HISTORIC AND DESIGN REVIEW COMMISSION

October 21, 2015

HDRC CASE NO: 2015-420
ADDRESS: 401 E LOCUST
LEGAL DESCRIPTION: NCB 1737 BLK 6 LOT 7 (CARLA HILLS)
ZONING: MF33 H
CITY COUNCIL DIST.: 1
DISTRICT: Tobin Hill Historic District
APPLICANT: Carlos McDermott
OWNER: Carla Properties LP
TYPE OF WORK: Approval for Tax Certification and Exterior Modifications
REQUEST:

Section to Change

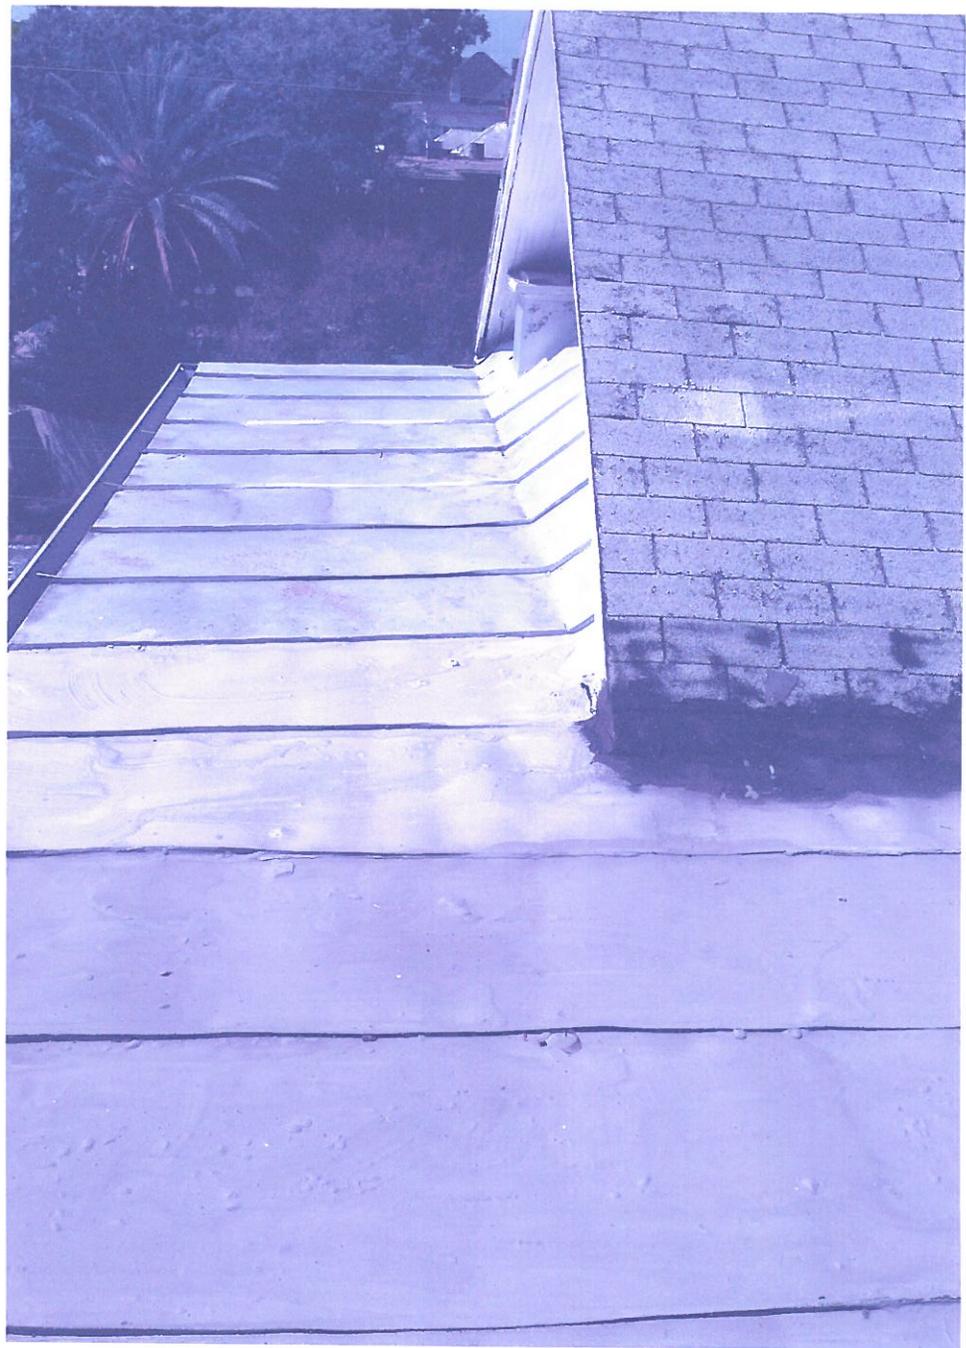
- d. The existing roof over the entrance is flat except for a steep angle that starts below the window sill at the front gable and slopes downward, meeting the flat roof.

- e. The homeowner is seeking to increase the pitch of the roof in order to mitigate the possibility of further water damage to the structure, as well as the burden of frequent necessary maintenance. The proposed modification is to build up the flat section so the roof line starts below the window sill of the front gable and slopes downward. This is meant to increase sufficient drainage.

- f. Staff finds that due to the lack of a single architectural style of the home and the roof being out of the public right-of-way due to its height that a change to the existing slope would not detract from the character of the structure or the district.

The existing roof line in the front of the building is almost flat and it is a metal roof. The rest of the structure is composition shingles. The flat roof has caused many a leak in the past and is evident in the rotten decking which is underneath.

I would propose to change the roofline in this section of the roof to increase the pitch and therefore prevent future leaks. The change would not be visible because of the height of the structure and it would be below the existing window. By changing the pitch, I would also be able to use the same asphalt shingles as will be used on the re-roof portion of this project.

Staff recommends approval of item 1 based on findings b and c. Staff recommends approval of item 2 based on finding a and d through f.
